Subject: Class 3 Permit Modification Request, Construction and Use of Hazardous Waste Disposal Units 11 and 12 for the Waste Isolation Pilot Plant Hazardous Waste Facility Permit Number: NM4890139088-TSDF

**Class 3 Permit Modification Request**

**Construction and Use of Hazardous Waste Disposal Units 11 and 12**

**Waste Isolation Pilot Plant  
Carlsbad, New Mexico**

**Figure G-6**  
**Approximate Locations of Boreholes in Relation to the WIPP Underground**

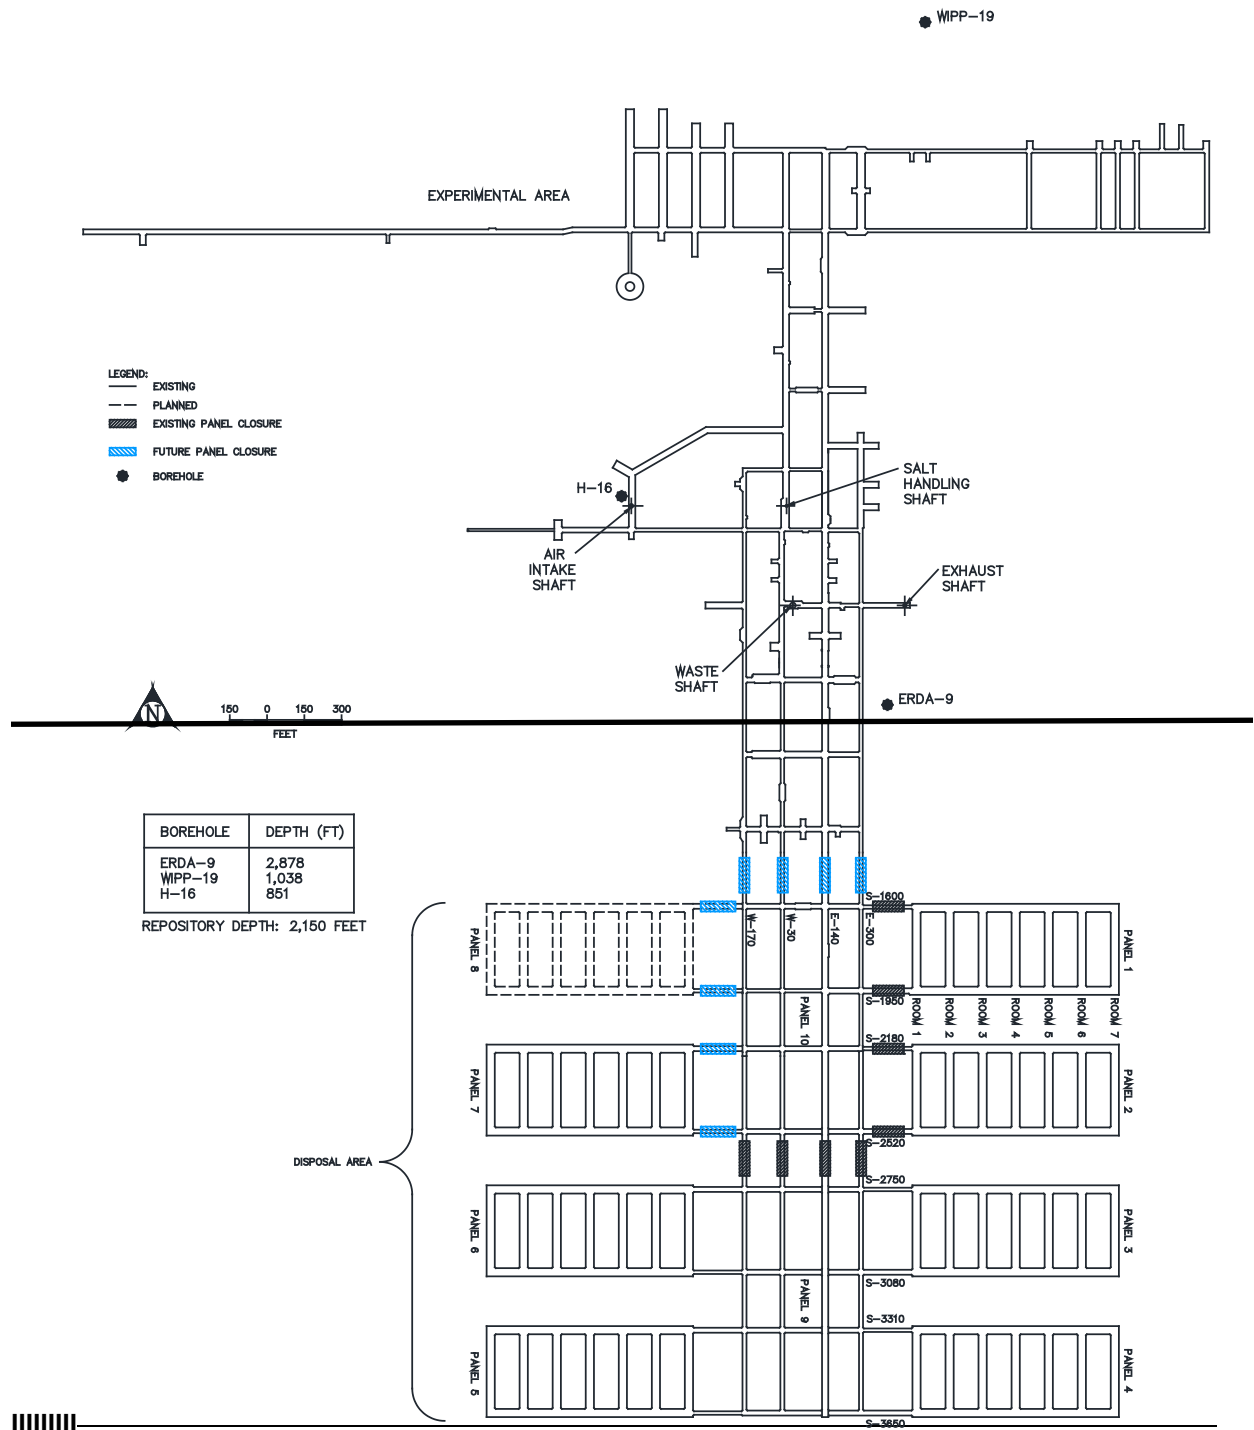
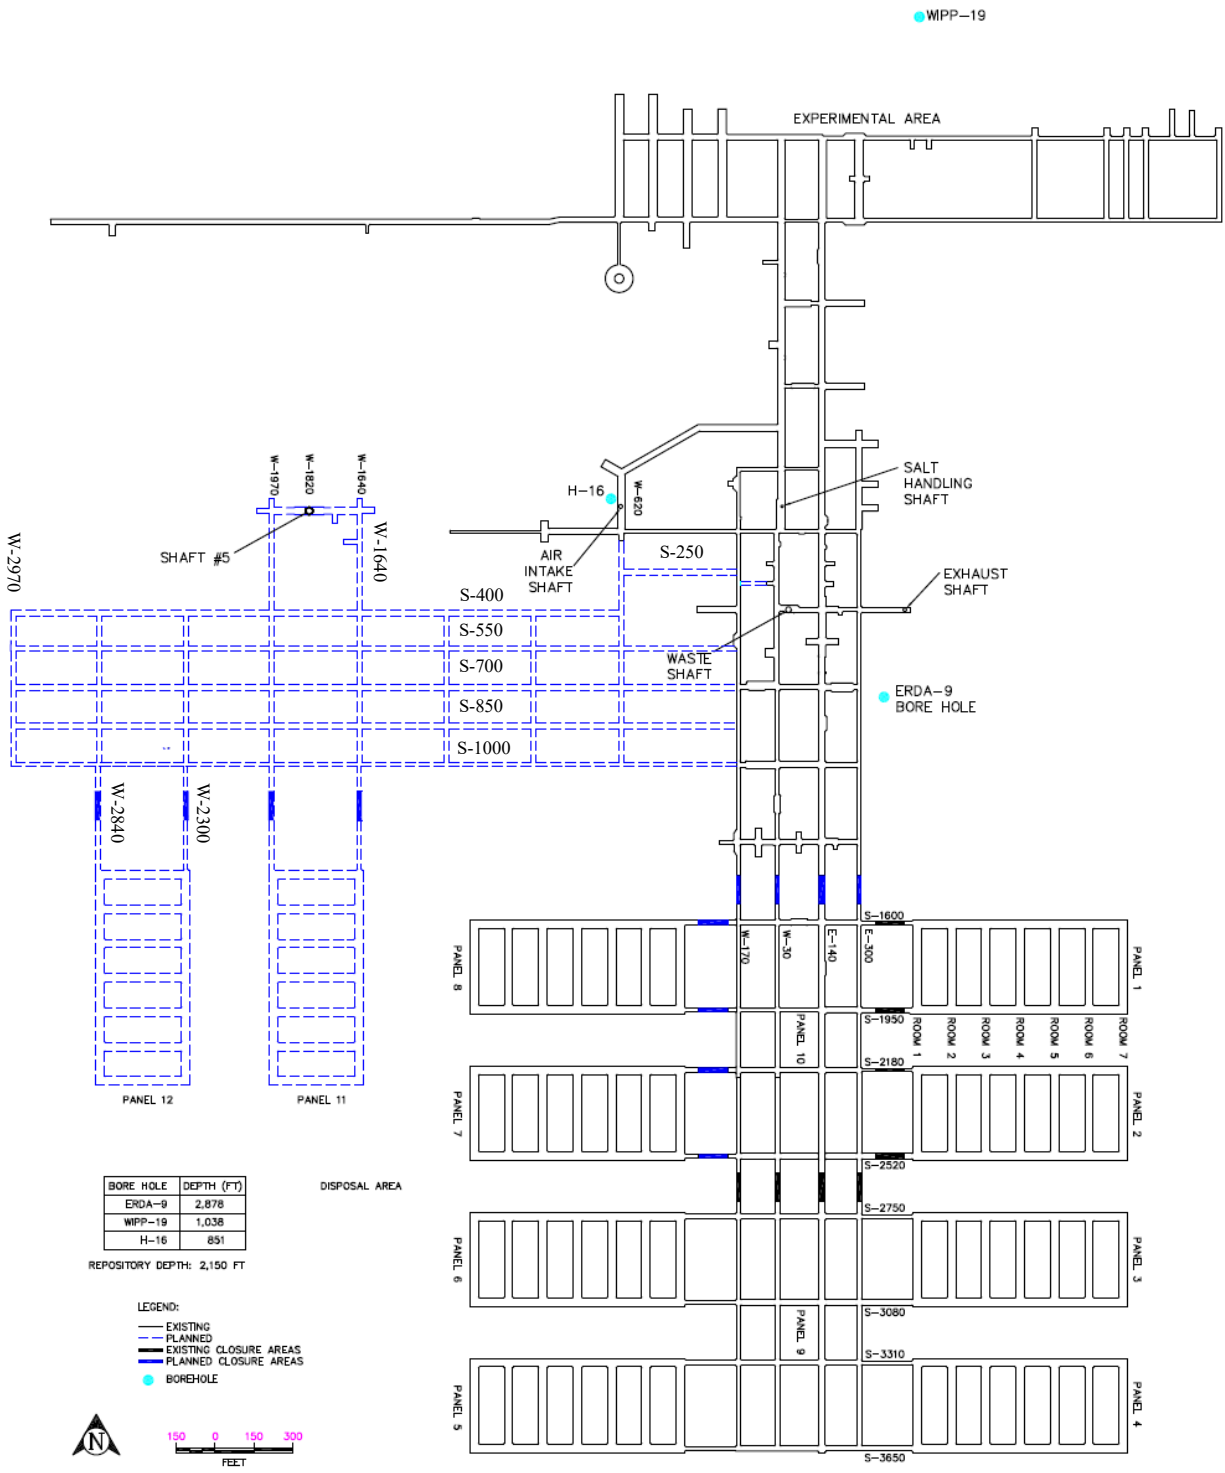
- Permit Attachment G, Figure G-6, *Approximate Locations of Boreholes in Relation to the WIPP Underground*, is being modified to include the location of the West Mains and Panels 11 and 12.

| Permit Part/Section           | Impact  |
|-------------------------------|---|
| Attachment G, Figures         | Modified Figure G-6, <i>Approximate Locations of Boreholes in Relation to the WIPP Underground</i> , to show the location of the West Mains and Panels 11 and 12. This change is needed to accurately describe the layout of the underground repository.  |

| Affected Permit Section        | Explanation of Change   |
|--------------------------------|---|
| Attachment G, Figure G-6       | Replaced figure to show the West Mains and Panels 11 and 12 for accuracy of the repository layout.  |

**Figure G2-1**  
**View of the WIPP Underground Facility**

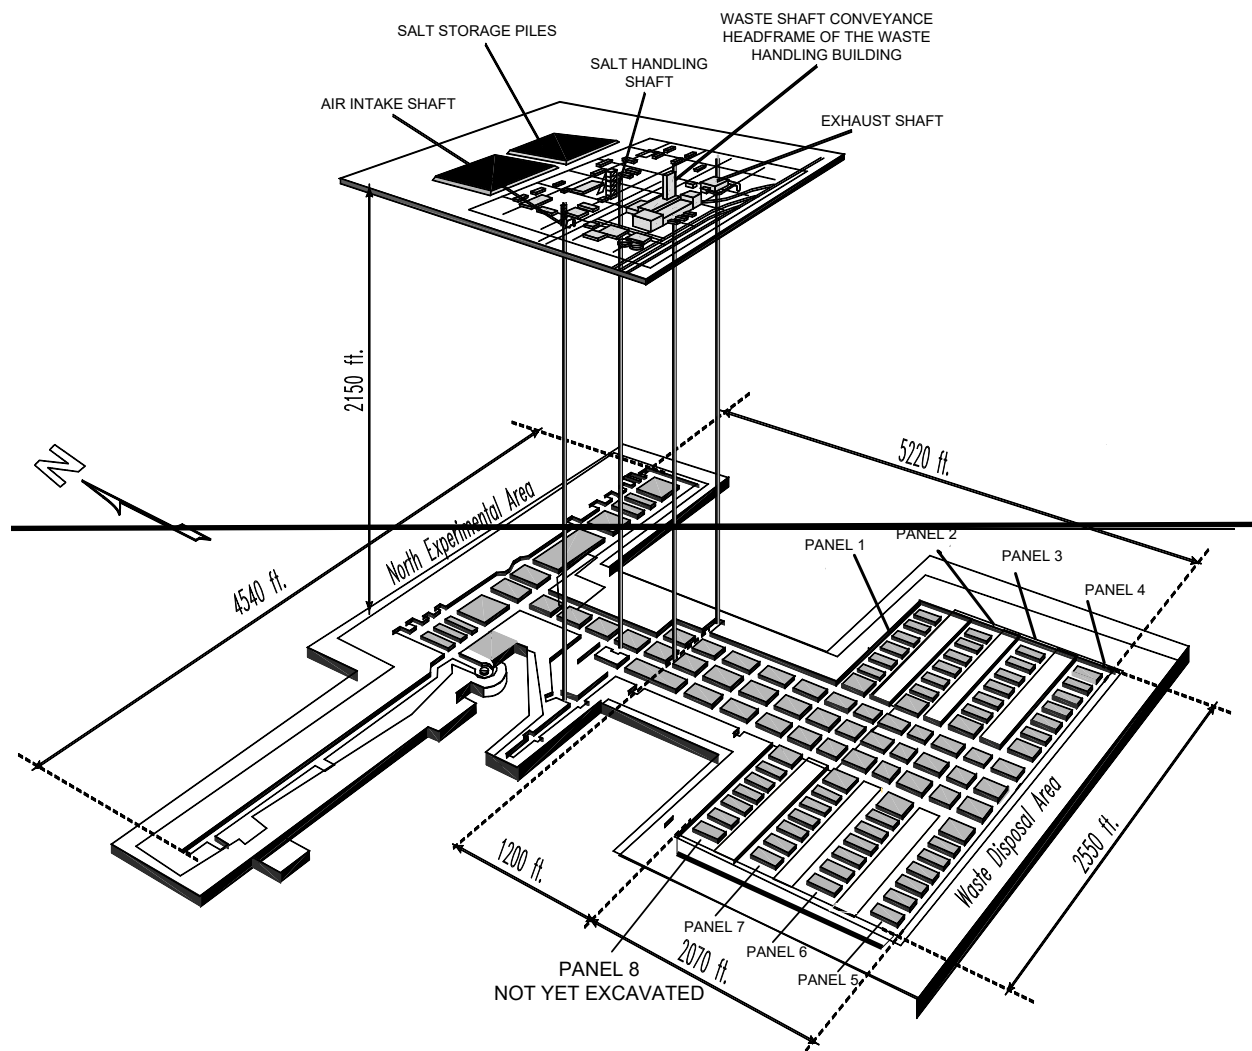
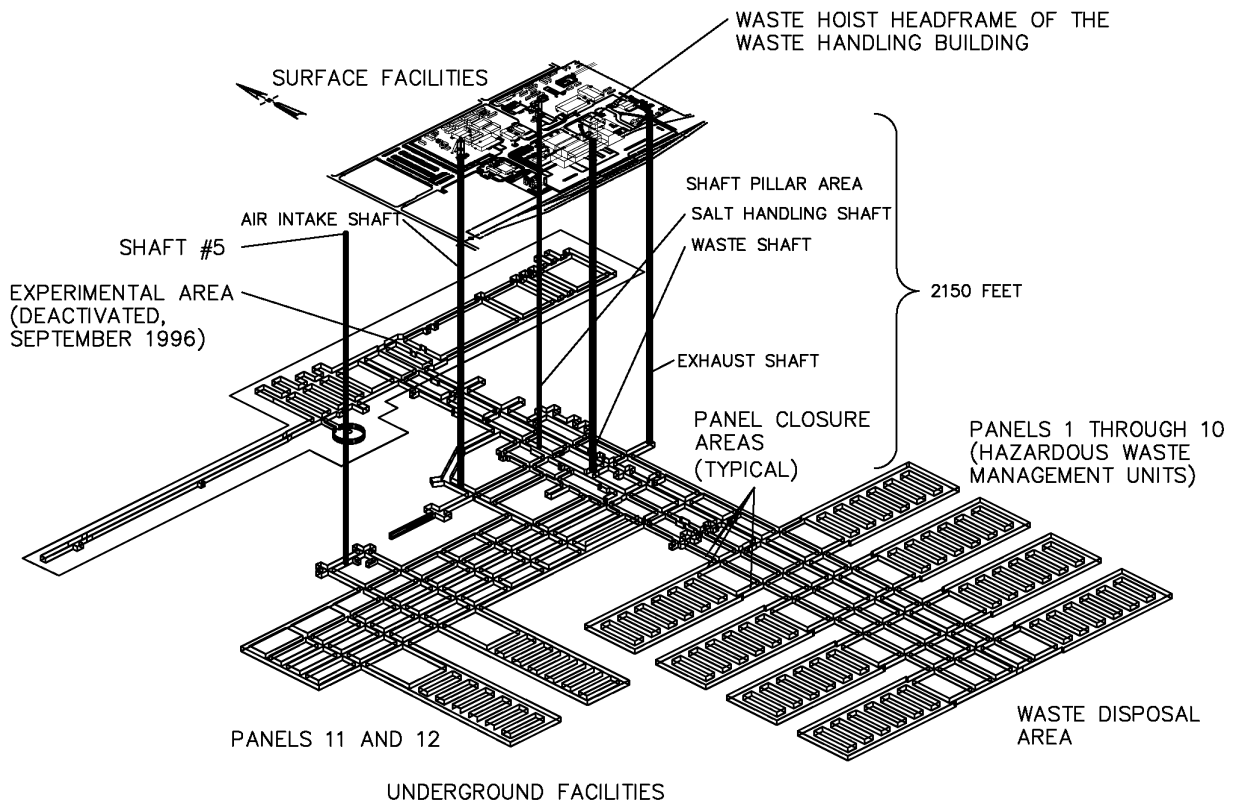
- Permit Attachment G2, Figure G2-1, *View of the WIPP Underground Facility*, is being modified to include proposed Panels 11 and 12, and to make this figure consistent with similar spatial view figures in the Permit.

| Permit Part/Section           | Impact  |
|-------------------------------|---|
| Attachment G2, Figure G2-1    | Added Panels 11 and 12 as well as the West Mains to the figure. This modification is needed to accurately reflect the underground layout and make consistent with similar spatial view figures in the Permit.   |

| Affected Permit Section        | Explanation of Change   |
|--------------------------------|---|
| Attachment G2, Figure G2-1     | Replaced the figure with a figure showing the Panels 11 and 12 as well as the West Mains, and to make consistent with similar spatial view figures in the Permit.   |

**Figure H1-1**  
**Spatial View of WIPP Surface and Underground Facilities**

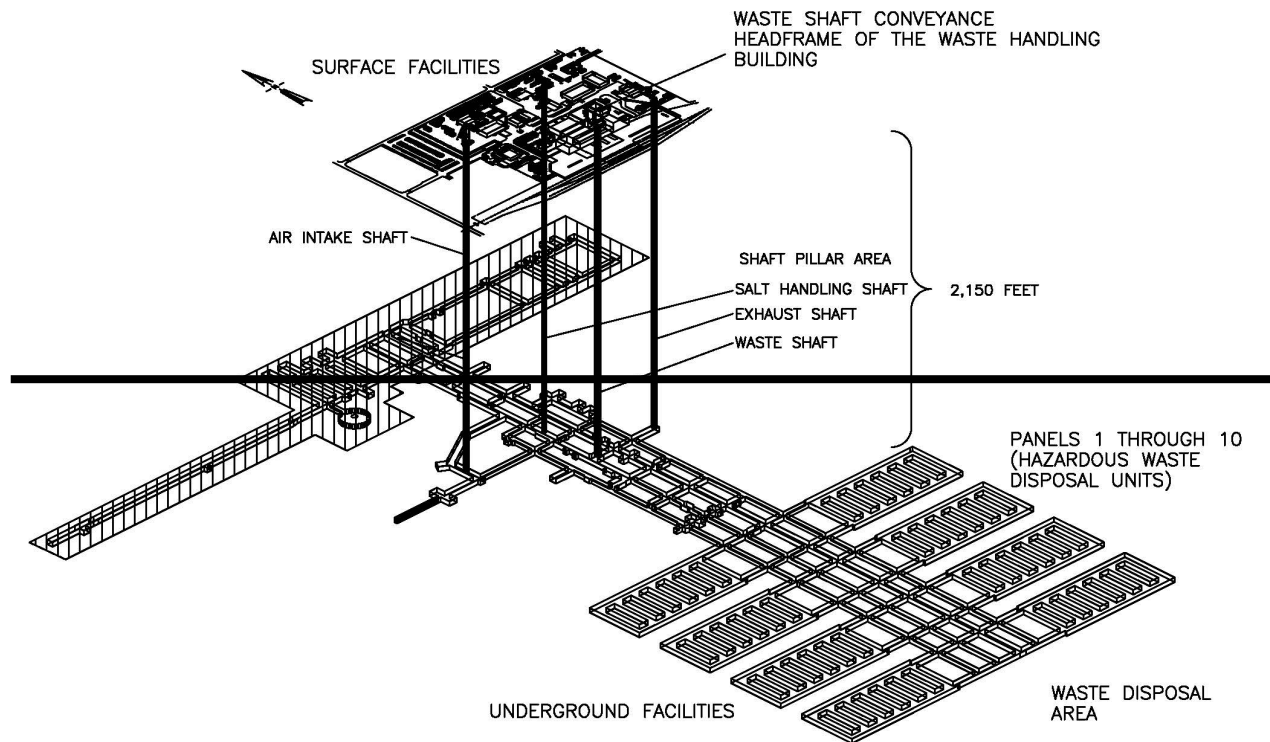
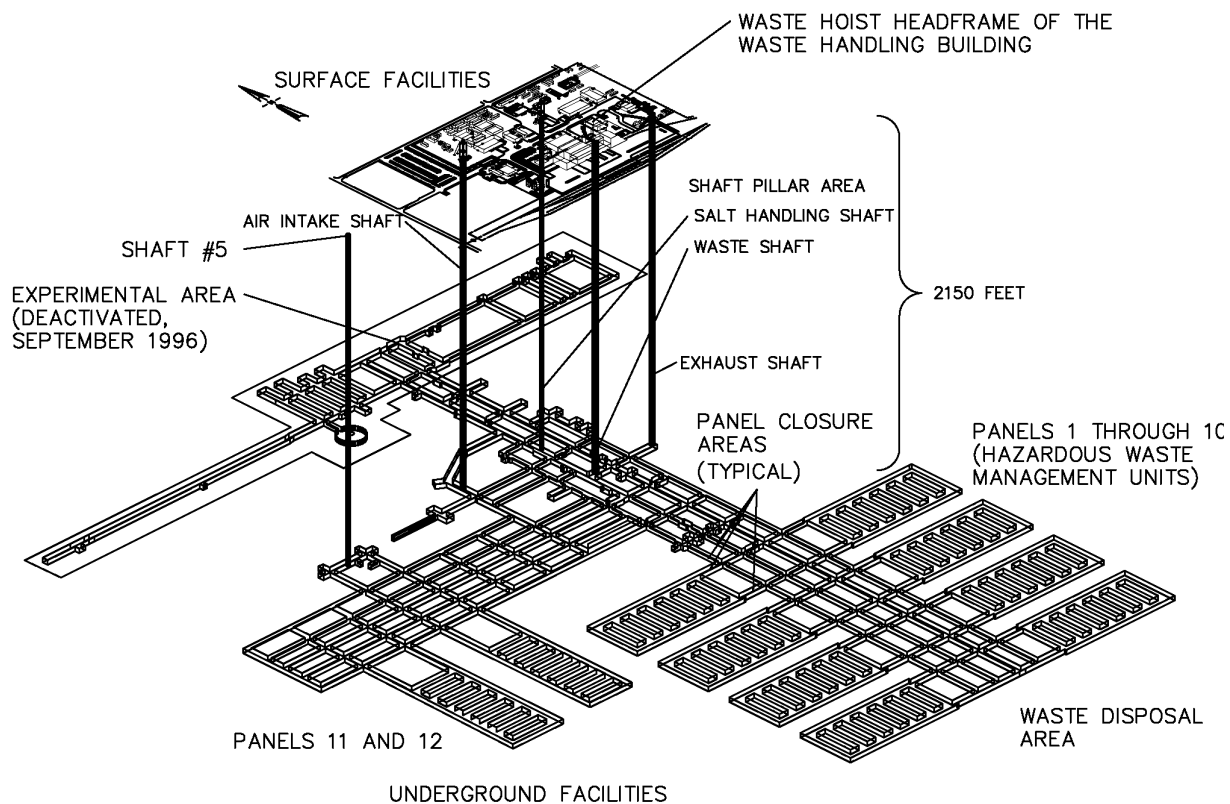
- Permit Attachment H1, Figure H1-1, *Spatial View of WIPP Surface and Underground Facilities*, is being modified to include the West Mains and Panels 11 and 12

| Permit Part/Section            | Impact   |
|--------------------------------|--|
| Attachment H1, Figures         | Modified Figure H1-1, <i>Spatial View of WIPP Surface and Underground Facilities</i> , to include the West Mains and Panels 11 and 12. This modification is needed for accuracy of the figure.   |

| Affected Permit Section        | Explanation of Change   |
|--------------------------------|---|
| Attachment H1, Figure H1-1     | Replaced figure to include the West Mains and Panels 11 and 12 in the spatial view of the WIPP facility.  |

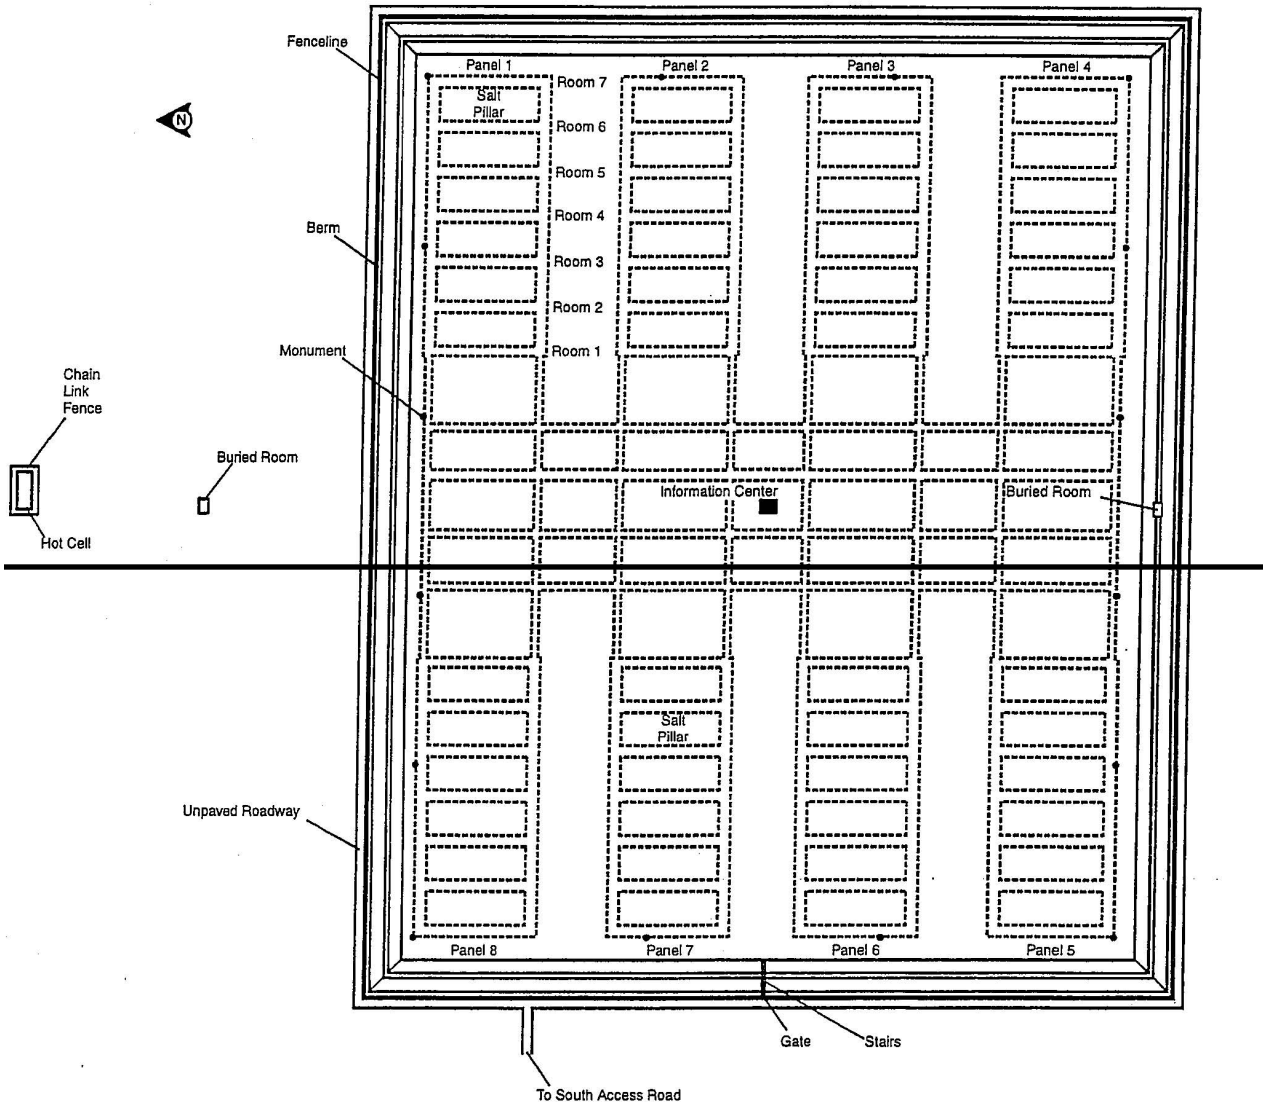
- Permit Attachment H1, Figure H1-4, *Perimeter Fenceline and Roadway*, is being modified to show the proposed layout of the perimeter fence with the West Mains and Panels 11 and 12 included within the fenced area.

| Permit Part/Section            | Impact   |
|--------------------------------|--|
| Attachment H1, Figures         | Modified Figure H1-4, <i>Perimeter Fenceline and Roadway</i> , to show the additional repository footprint fencing encompassing the area around the West Mains and Panels 11 and 12.   |

| Affected Permit Section        | Explanation of Change   |
|--------------------------------|---|
| Attachment H1, Figure H1-4     | Replaced figure to show the adjoining perimeter fence line and roadway around the Panels 11 and 12 footprint.   |
